## Quality check of the Groningen accelerometer network

Document Nr.: 1018-0338-001

Date: 1 May 2019

Response to KNMI reviews for R1 of the report

Figure 9. Gravity test results for all 5 sensors

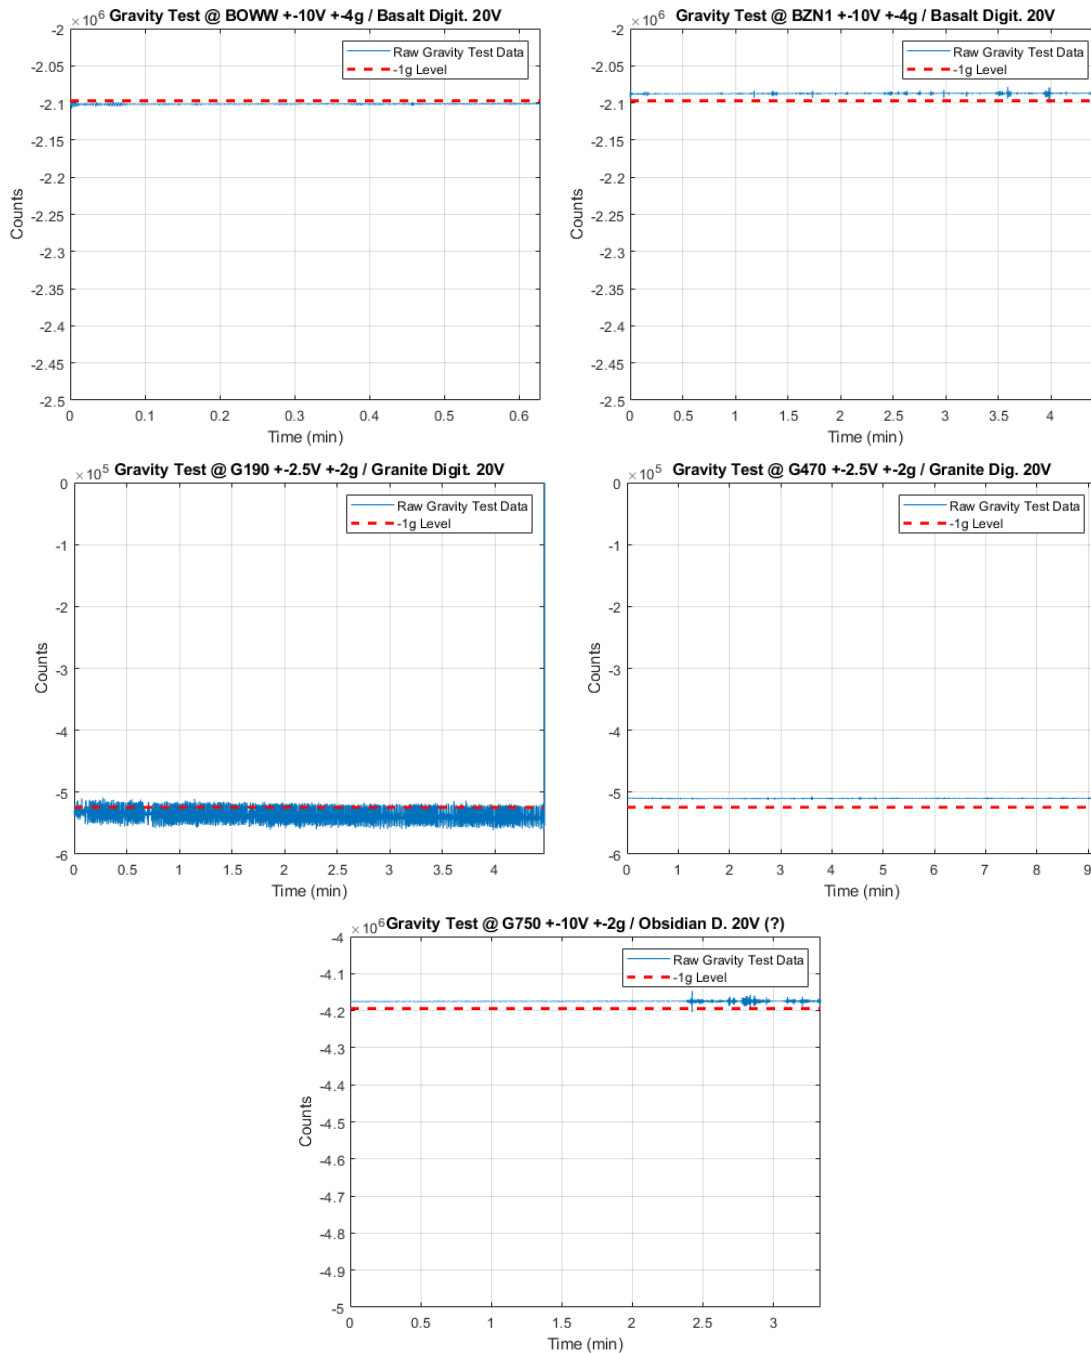
*P17: “G470 sensor behaves like a +- 4g sensor”. This statement comes without argumentation. In fact, this statement is contracted in the same report on Figure 9, in which it is shown that both G190 and G470 yield an output in counts that is consistent with a 2g setting.*

It was not possible to report the “as installed” situation of G470 since we do not have the original digitizer and the original cable. We only made an assumption, as explained in the report, thus Figure 9 is based on that assumption.

Figure 15. Unfiltered G190 East Component for the 28<sup>th</sup> of February 2019 earthquake

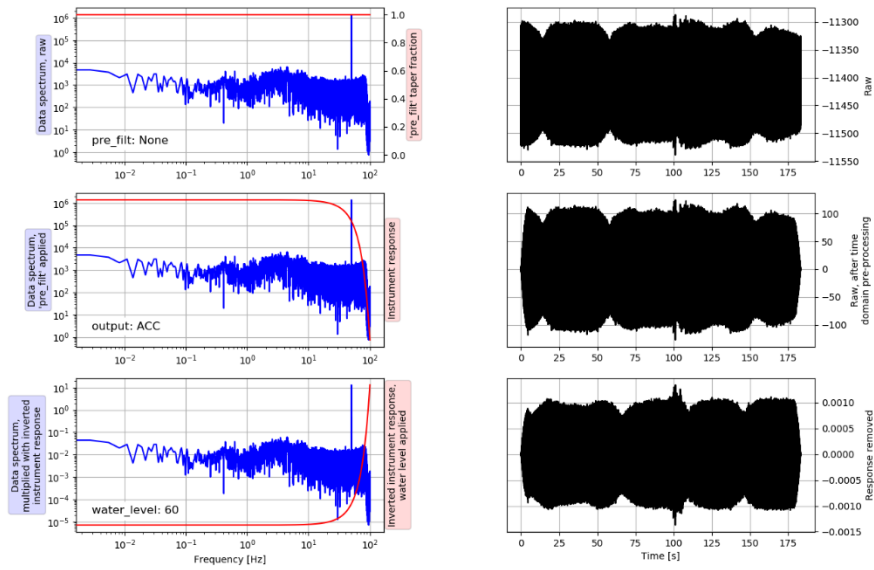
*- “G190 and/or its digitizer exhibit high noise and need to be checked”. Please refine this conclusion by adding the sensor to another digitizer. If this is a sensor test, one needs to be able to conclude whether it is in fact the sensor, not the digitizer, that picks up heavy 50 Hz distortion (as well shown in Figure 15).*

50Hz is the “usual” noise since it comes from the frequency of electricity used in Europe. What we are talking about is the unusual noise, that we cannot see in BOWW, for example. When G190 sensor is connected to the Granite, by using the cables of the B-stations, we get very high noise in the raw data. This is what we reported and commented. That is pretty much evident in Figure 15 in the raw data. It is not in our scope to go further.

Figure 17. PGA values recorded by the KNMI sensors in respect to the reference sensors in Direction 1

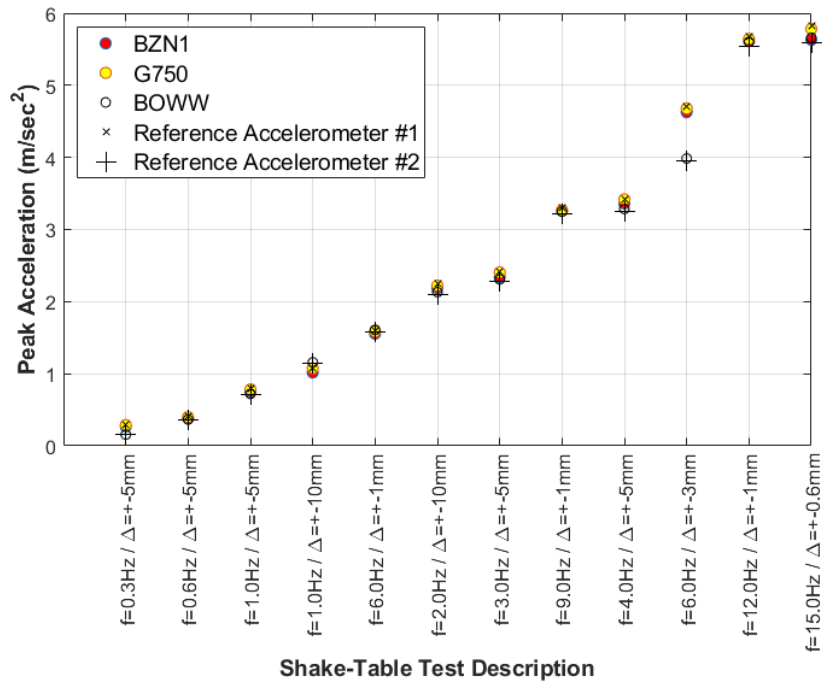
*“BZN1 station is known to have issues”. Please give arguments. In Figure 17 it is shown that in fact BZN1 yields good output.*

**Figure 2-4 : Arrival times of P-waves (red circles) and S-waves (blue squares) based on manual picking of recordings for the Zeerijp event. The curves show the derived polynomial functions used to infer P and S arrival times for the other events.**

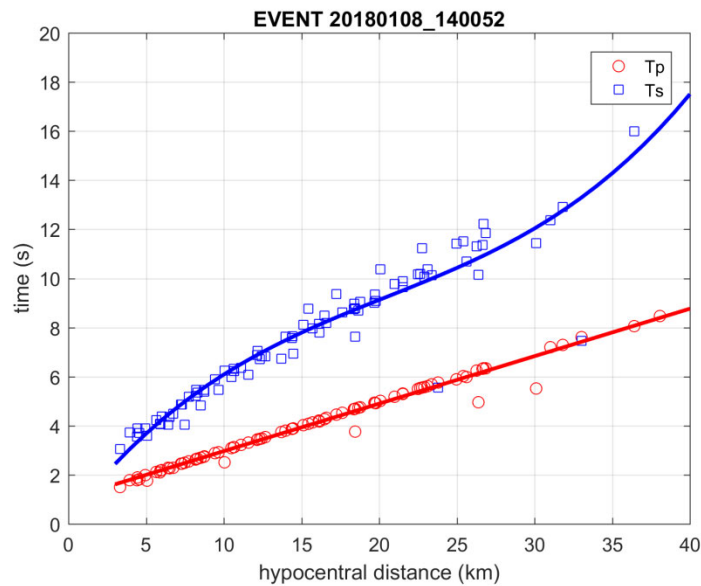
P7: Figure 2-4: the last S-wave onset pick largely affects the fitted  $T_s$  line. This pick does not make sense. It would imply that S-waves propagate relatively fast up till 30 km and afterwards slow down considerably.

The last S-wave onset pick correspond to station N030 for which windows identification seems appropriate (see figure 3), although we recognized that the S-wave onset is probably slightly later in time. As long as the main S-wave energy is included in the window, small differences in the arrival times will have a negligible impact on the selected cut-off frequencies of the filter.

Figure 3-4 : Horizontal B-to-G Fourier Amplitude Spectra (FAS) ratio plotted for all considered pairs of stations and all events. The median ratio and its standard deviation are shown in blue.

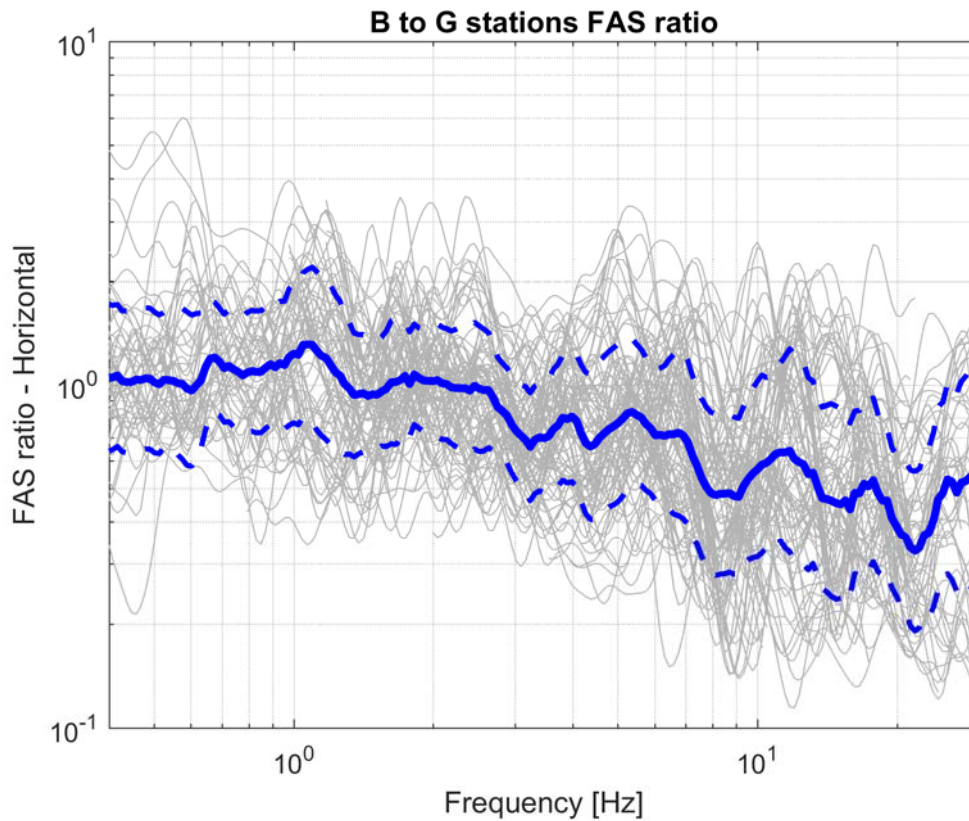
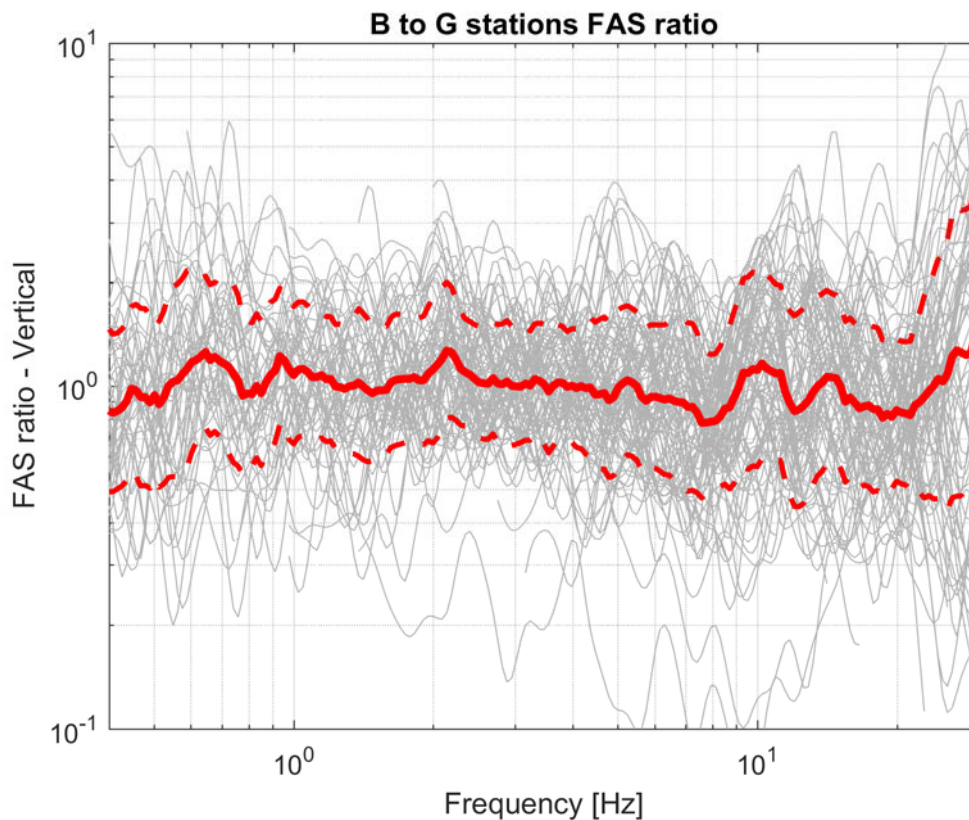
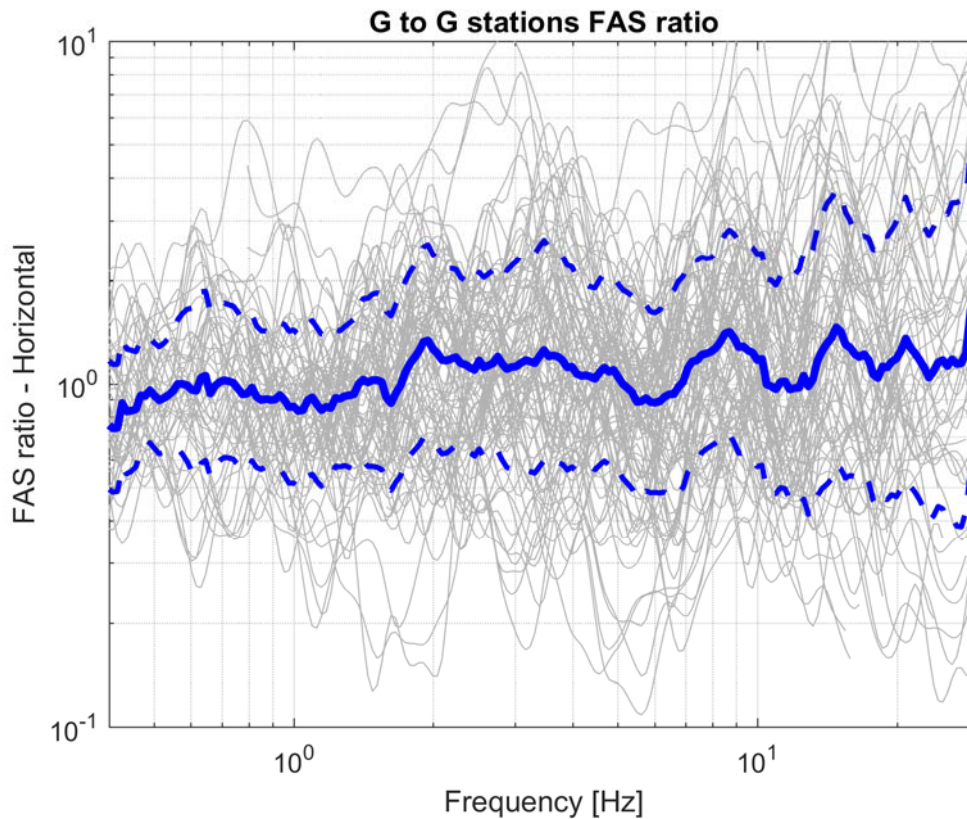
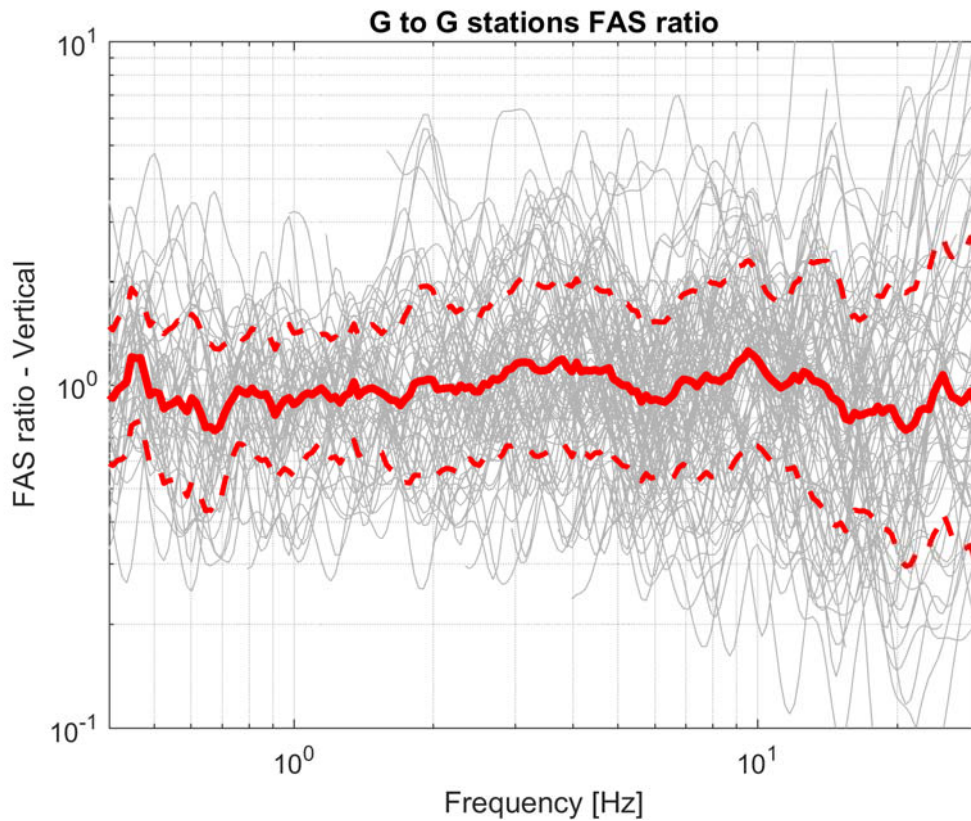
2] The results in Figures 3.4, 3.5, 4.2 and 4.3 show a large variability in spectral ratios as a function of frequency. There is unfortunately no discussion in the document on the significance of the results in view of the large variability in the ratio's.

These figures lump together the ratios from all the considered station pairs and, as a consequence, it is expected to see larger variability with respect to the variability of ratios for single pairs (e.g., figure 3-2). In order to show the significance of the median ratios we added in each figure the standard deviation of the distribution. We note that the standard deviation around the median for PSA ratios is of the same order of the aleatory variability of the GMM V5 and of recent GMPEs in general. For example, the  $\sigma_{in}$  of the B-to-G ratios is about 0.45 for PGA which is smaller than the value of about 0.6 given by the GMM V5 (and by e.g., NGA-west 2 GMPEs). The standard deviation is slightly larger for G-to-G stations ratios ( $\sigma_{in} = 0.7$ ) but again consistent with the GMM V5.
